## ASSESSMENT REPORT

### MIXED-USE DEVELOPMENT, KIRRAWEE BRICK PIT MP 10\_0076 MOD 8

On 28 February 2017, the Proponent lodged a section 75W modification request (MP 10\_0076 MOD 8) seeking approval to remove the requirement to provide a lake within the public park. The removal of the lake would provide additional useable space for the community.

Figure 2: MOD 3 STIF Regeneration Plan.

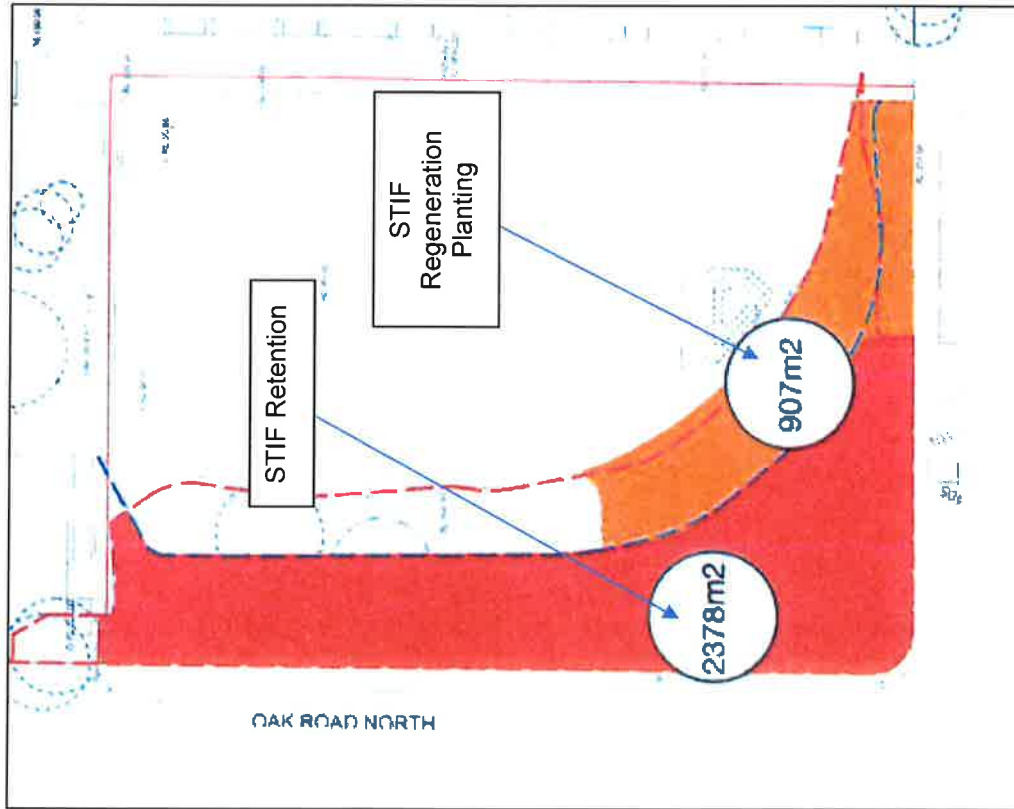
MOD 3 requires 907 m<sup>2</sup> of STIF regeneration within a consolidated area of the park, shown in **Figure 2**. The proposal seeks to amend the regeneration area and plant 944 m<sup>2</sup> of STIF across five separate sites as shown in **Figure 3**.

Figure 3: Proposed Areas of STIF Regeneration.

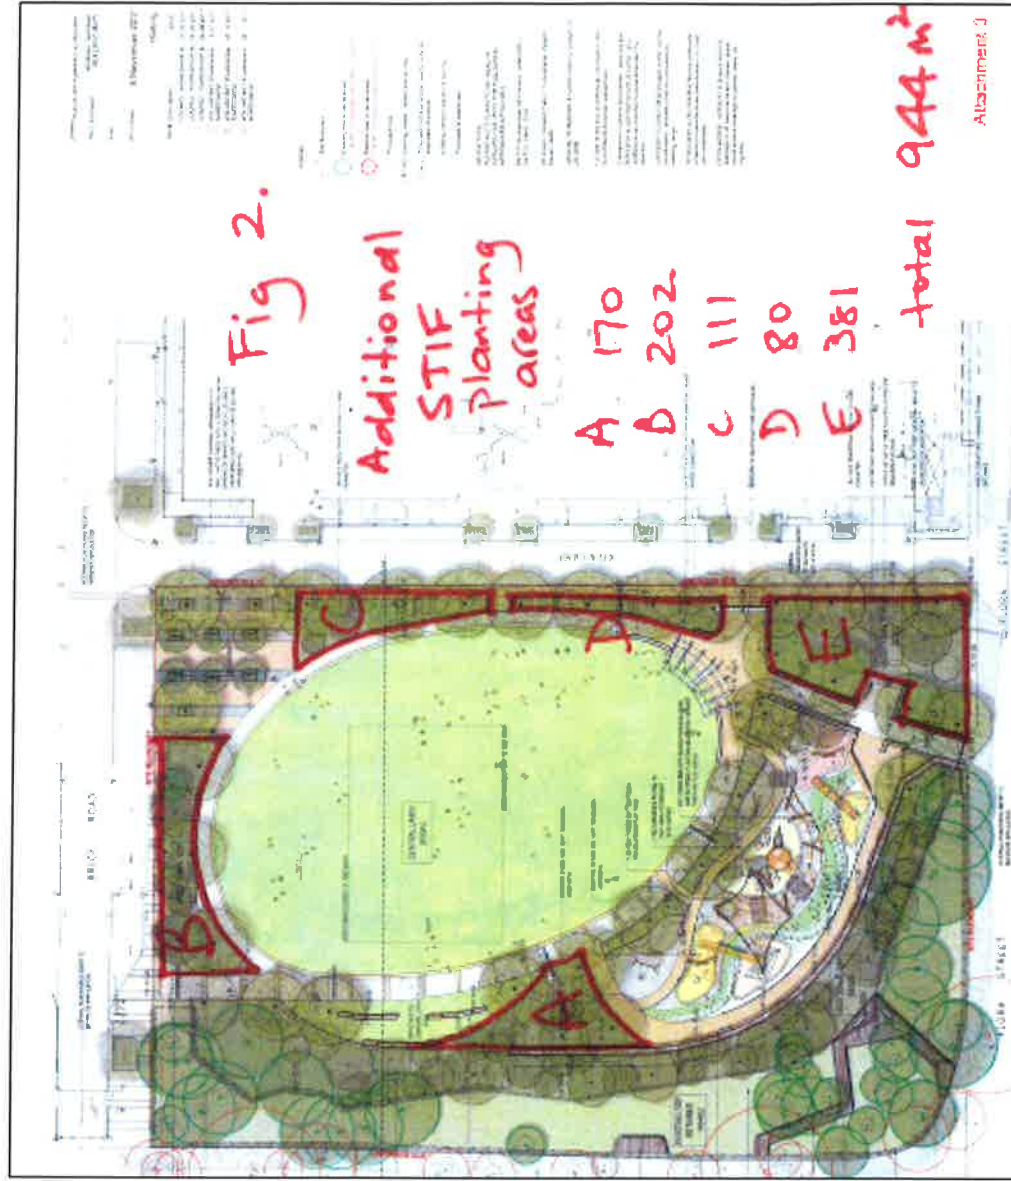
While the proposal exceeds the total amount of STIF required to be planted on the site, OEH raised concern that certain areas (C and D) are sub-optimal from a conservation perspective, as they have a high perimeter to area ratio, and are isolated from the existing STIF. OEH raised concern that these areas should not be included in the total area of STIF regeneration.

- identified possible areas for an additional 800 m<sup>2</sup> of STIF regeneration as a result of the removal of the lake (see **Figure 4**)
- noted Areas C and D are located to provide a visual buffer, and that the majority of regenerating STIF is within proximity to existing STIF
- noted that with the increased density approved on the site, the demand for recreation facilities has increased, making it difficult to provide contiguous areas of STIF.

The Department notes OEH's concerns about the location of Areas C and D of regenerating STIF and accepts that these areas should not be included in the calculation towards the required 907 m<sup>2</sup> of STIF regeneration.

However, the Department considers the proposal (excluding Areas C and D from calculations) would still provide an acceptable outcome, as:

- the inclusion of the 800 m<sup>2</sup> would ensure the total amount of STIF regeneration on the site (excluding Areas C and D) is still 646 m<sup>2</sup> more than that approved under MOD 3
- the 800 m<sup>2</sup> of additional STIF would be located so that it is contiguous with existing STIF
- a visual buffer would be provided between the park and the development through the retention of Areas C and D.
